Drain: BRIDLEWOOD DRAIN **Drain #:** 66
Improvement/Arm: BRIDLEWOOD - SECTION 4
Operator: JPH **Date:** 10-30-03
Drain Classification: Urban/Rural **Year Installed:** 1992

Drain-Improvement: BRIDLEWOOD DRAIN - SECTION 4

RE: Bridlewood Drain-Section 4

CONSTRUCTION PLANS FOR BRIDLEWOOD SECTION IV

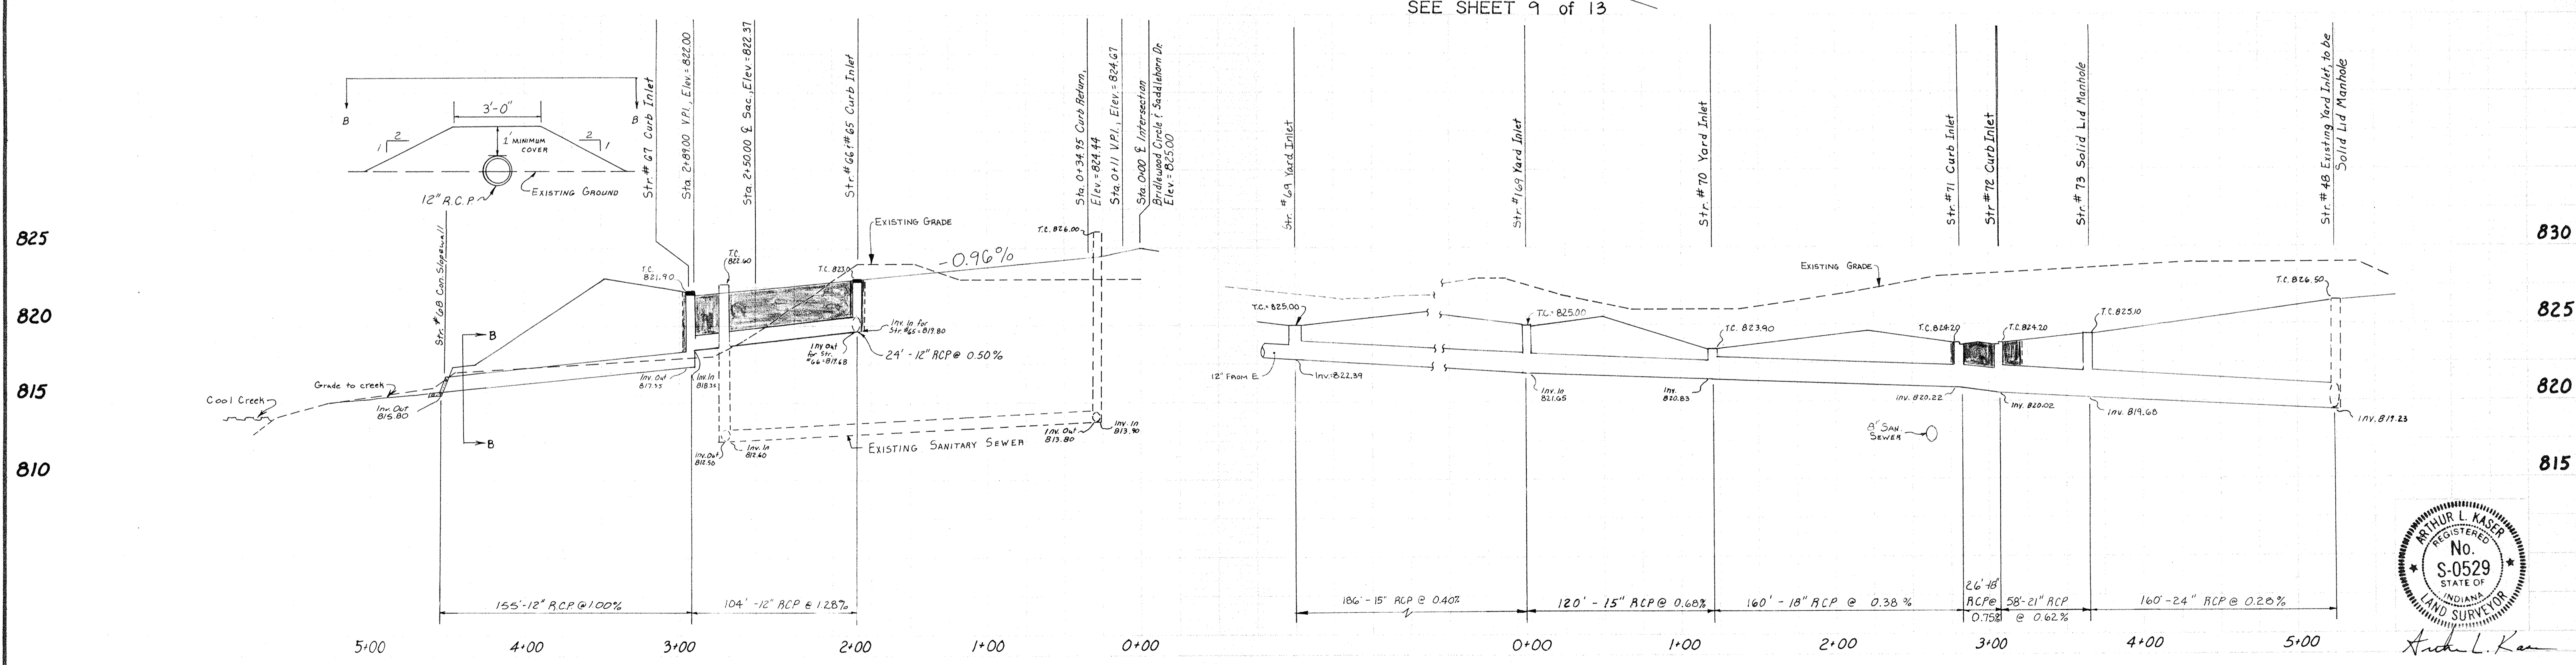
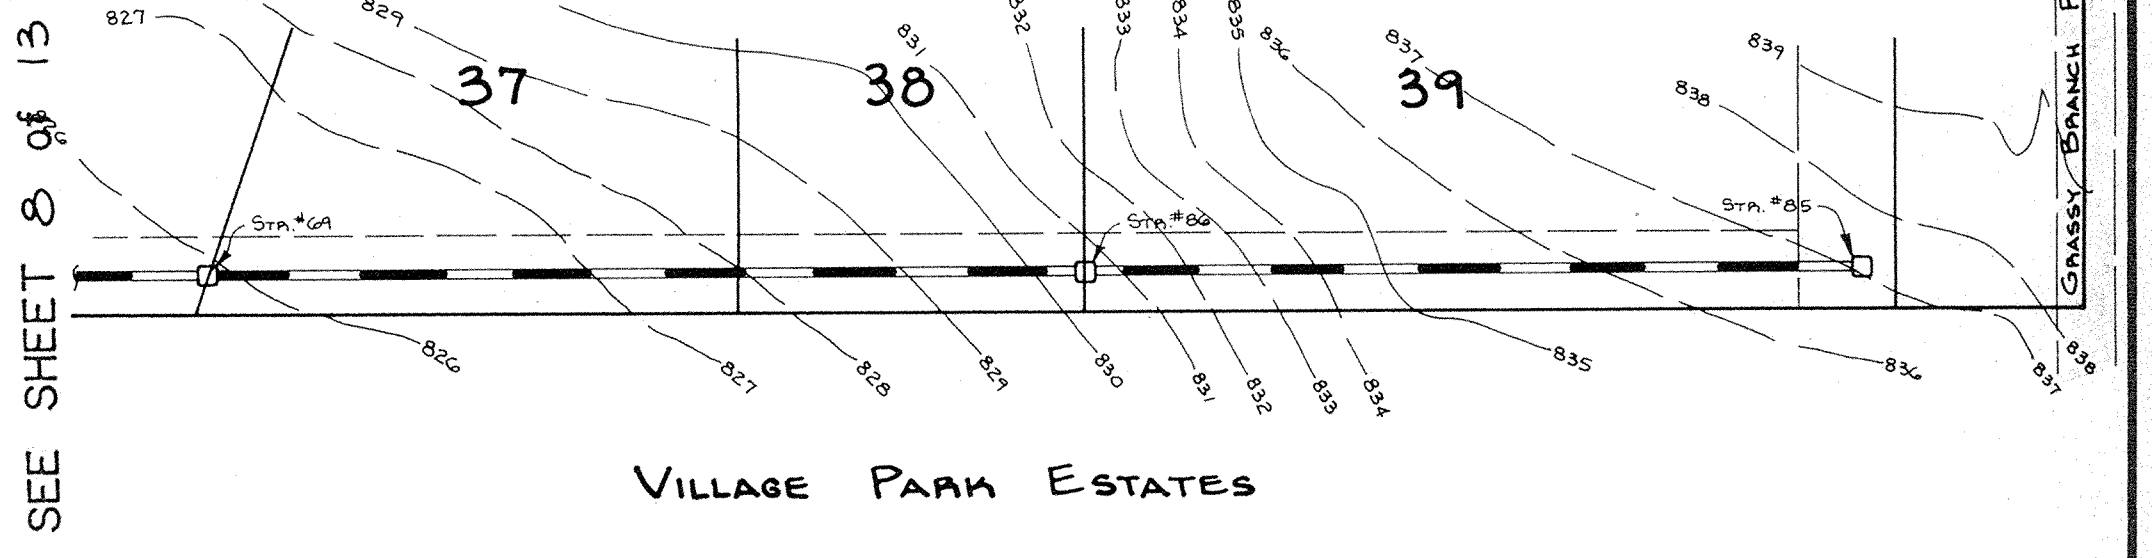
The correct total of six (6") inch SSD is 6,504 feet. Structure 73 to 48 consists of twenty-four (24") inch RCP at 162 feet in length. This structure was upgraded from a twenty-one (21") inch RCP at 160 feet in length.

DATES AND REVISIONS		TITLE	
		STORM STRS. 47, 74-79, 80	
		BRIDLEWOOD SEC. IV	
DESIGN BY		DRAWN BY	
		CHECKED	
		APPROVED

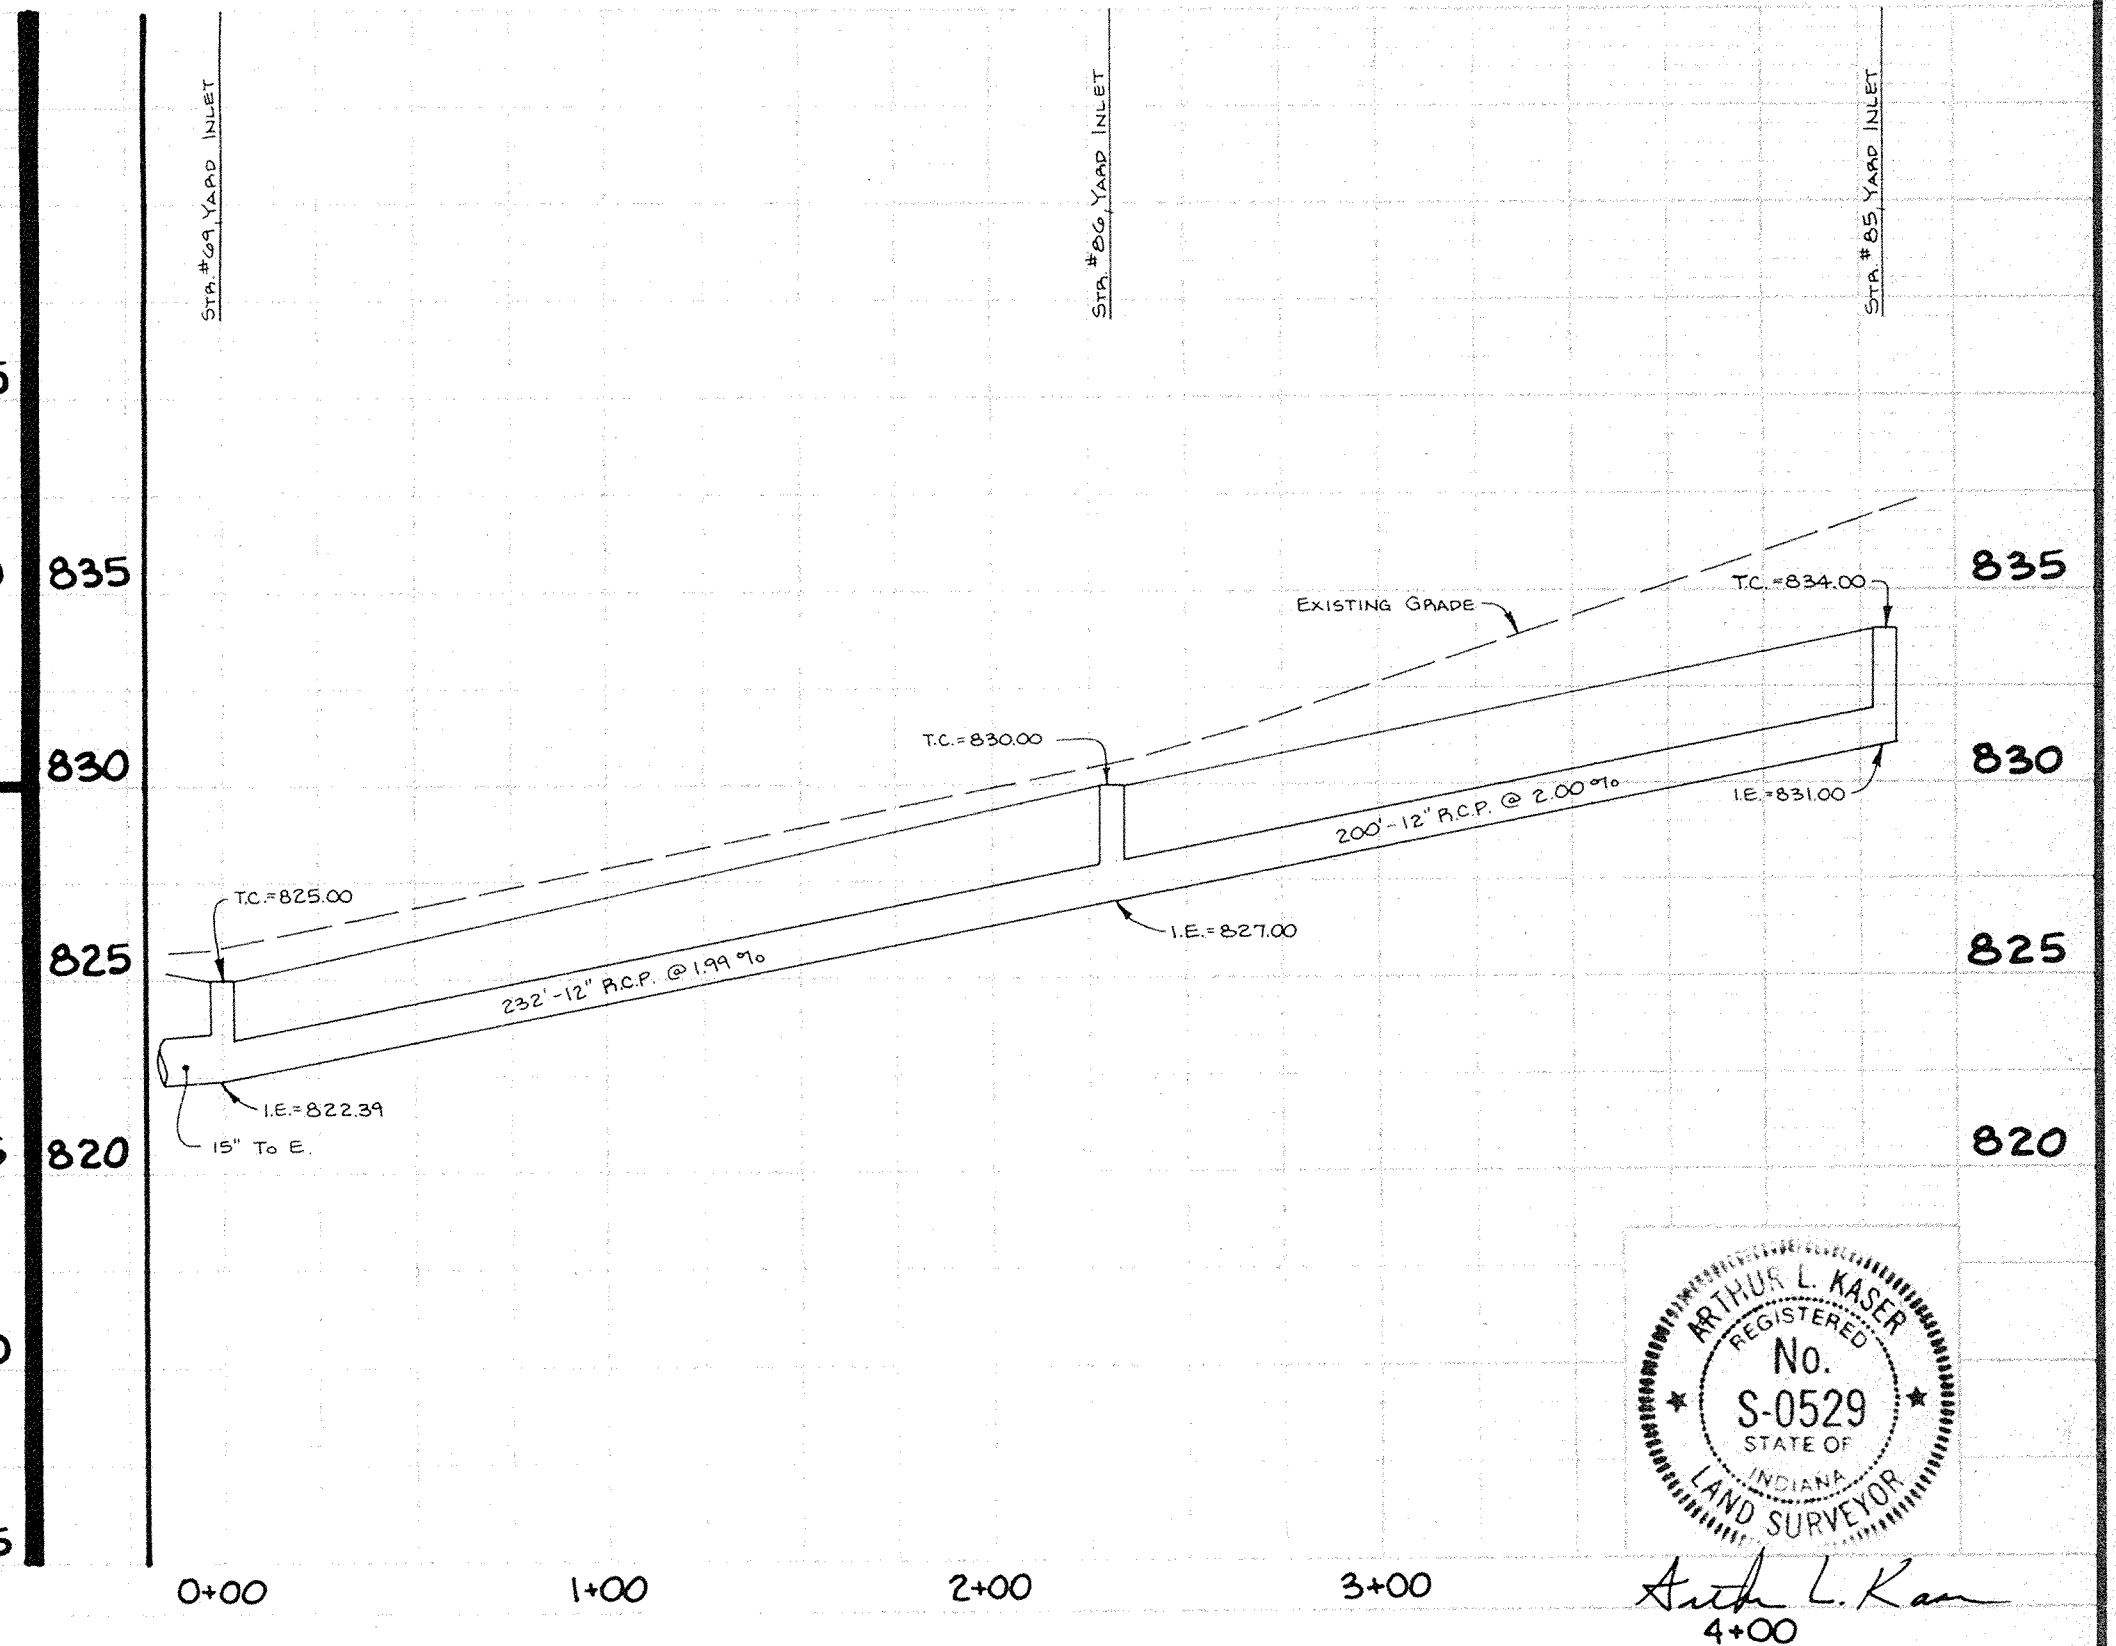
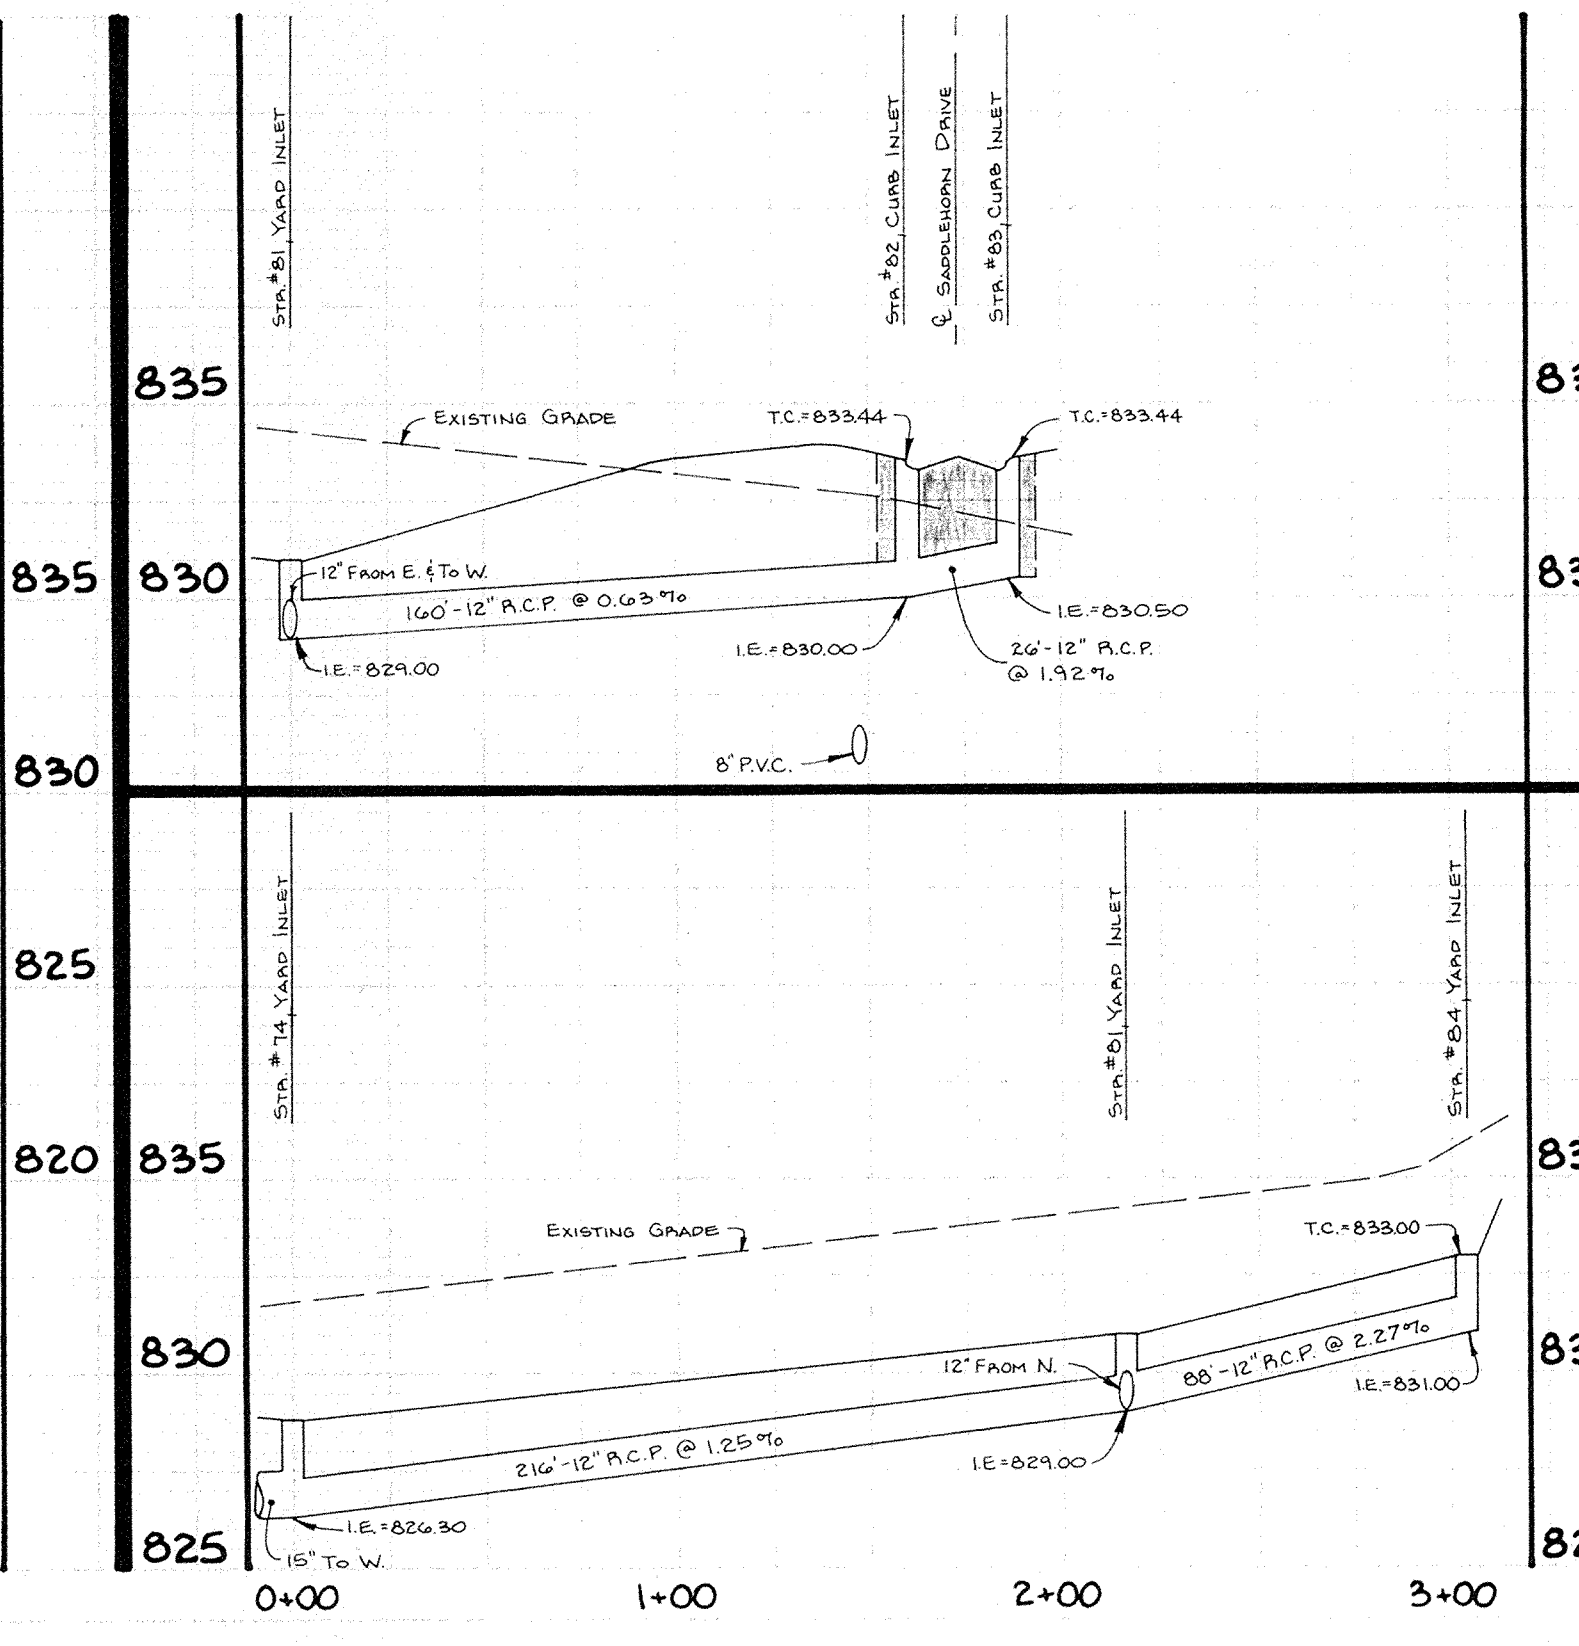
STR 79 to 80	12"	RCP	lengthened	from 44'	to 47 feet	✓
STR 73 to 72	21"	RCP	shortened	from 58'	to 53 feet	✓
STR 72 to 71	18"	RCP	shortened	from 26'	to 24 feet	✓
STR 71 to 70	18"	RCP	lengthened	from 160'	to 161 feet	
STR 67 to 68	12"	RCP	lengthened	from 155'	to 226 feet	✓
STR 74 to 75	15"	RCP	lengthened	from 36'	to 38 feet	
STR 76 to 77	15"	RCP	lengthened	from 115'	to 117 feet	
STR 78 to 79	18"	RCP	shortened	from 32'	to 31 feet	
STR 79 to 47	18"	RCP	lengthened	from 192'	to 193 feet

The six (6") inch SSD across the rear of Lots 45 through 48 and Lots 37 to 39 were replaced with twelve (12") inch RCP. The following structures and lengths were added accordingly:

STR 85 to 86	12"	RCP	at 200 feet in length
STR 86 to 69	12"	RCP	at 235 feet in length
STR 84 to 81	12"	RCP	at 89 feet in length
STR 81 to 74	12"	RCP	at 216 feet in length
STR 83 to 82	12"	RCP	at 24 feet in length
STR 82 to 81	12"	RCP	at 160 feet in length

The length of the drain due to the changes described above is now 9,650 feet.
